Donald C. Cook Nuclear Plant Unit Nos. 1 and 2
Docket Nos. 50-315 and 50-316
License Nos. DPR-58 and DPR-74
MINUTES OF SEPTEMBER 13, 1983, NRC/AEPSC MEETING ON
ENVIRONMENTAL QUALIFICATION

MINUTES OF SEPTEMBER 13, 1983, NRC/AEPSC MEETING

DONALD C. COOK NUCLEAR PLANT UNIT NOS. 1 AND 2

REVIEW OF FRC TER ITEM NO. 81 RADIATION QUALIFICATION

Figure 8. Temperature/pressure profile for simulation of Loss-Of-Coolant Accident environment.

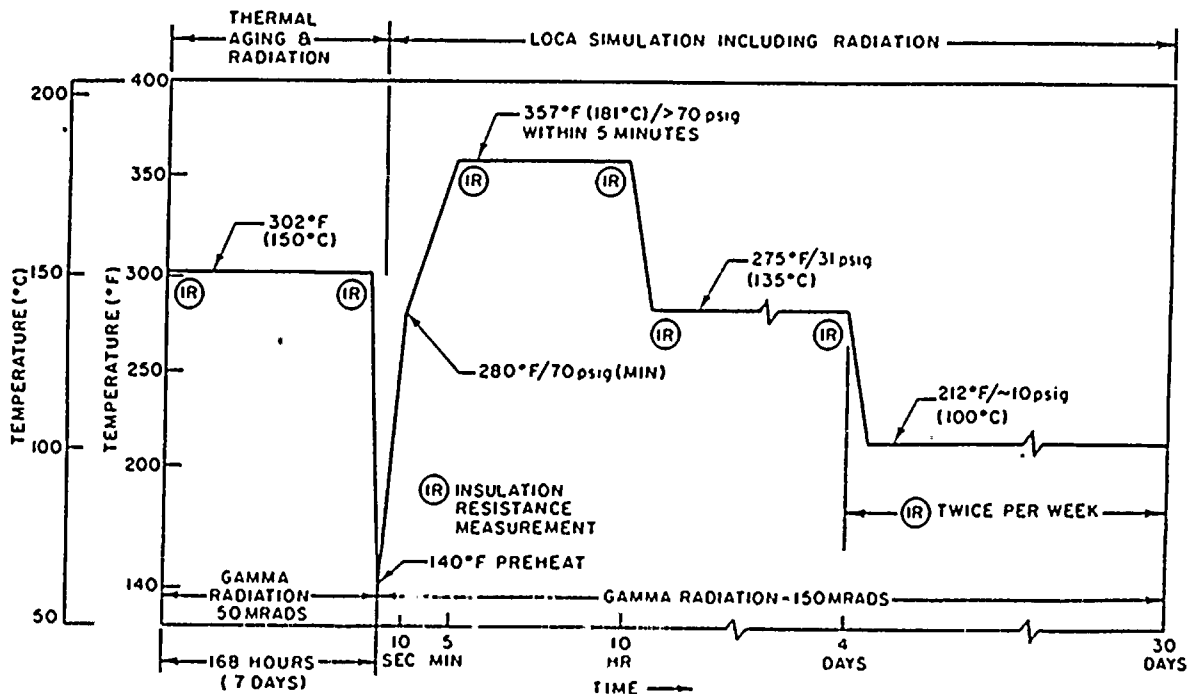
Splice connection TP-2 is a Raychem Corporation splice that has also been qualified by Raychem Corporation under test report F-C4033-3 (EQ central file Ref #14). The total radiation dose used during this test was of 200 mrad (see attached test profile).

SCEW sheets TP-2 for both DC Cook units will be revised to reference both the Westinghouse - Canada and the Raychem test reports.

To further illustrate the double break philosophy, refer to attached cable schematic 84851-12 indicating the control circuit cable run for pressurizer power relief valve NRV-151.

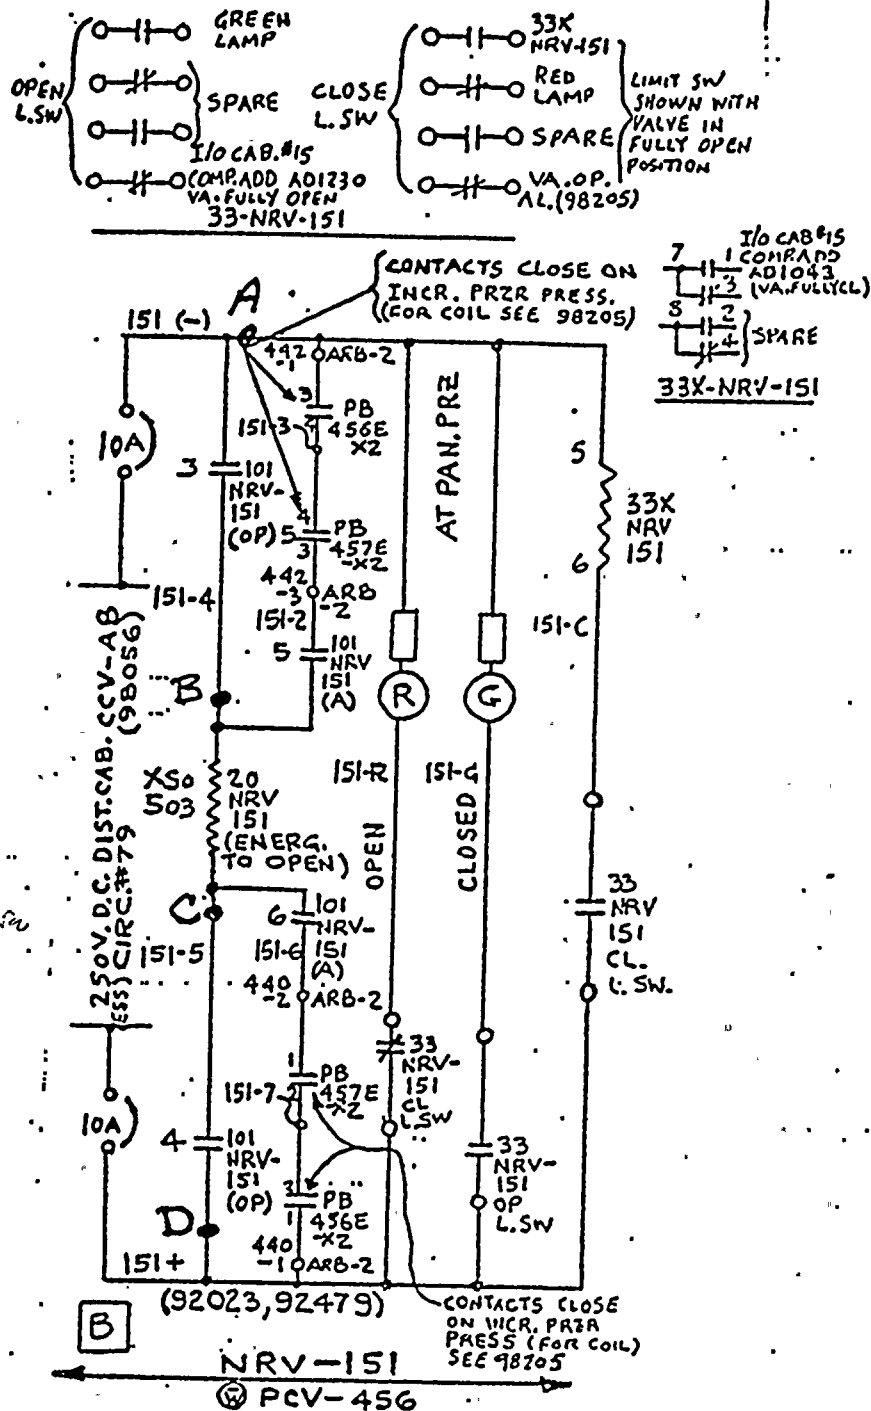
The possibility of spurious operation of motor operated and air operated valves due to short circuits is minimized by AEP's philosophy of double breaking of the control circuit. The double break concept, as illustrated in enclosed schematic, requires control contacts be located in both polarities of the actuating circuit. With this configuration, a short circuit between points A to B or between points C to D cannot cause a spurious operation of the valve. A short circuit between points A to D will cause protective devices upstream to isolate the short. This will result in motor operated valves remaining in the position just prior to the short circuit and air operated valves traveling to their de-energized position.

A spurious operation can only occur with a simultaneous short circuit from points A to B and C to D and a high impedance path maintained from points B to C.

It should be noted that points A, B, C and D are all located in very close proximity of each other. The selective short circuits without a circuit fault is extremely unlikely when the double break criterion is applied.

A spurious opening of the pressurizer relief valve would require a simultaneous short circuit between two (2) separate pairs of conductors located in the same cable jacket, without the two (2) pairs shorting to each other.

The likelihood of such discriminating short circuits
occurring in a single multiconductor cable is remote at best.
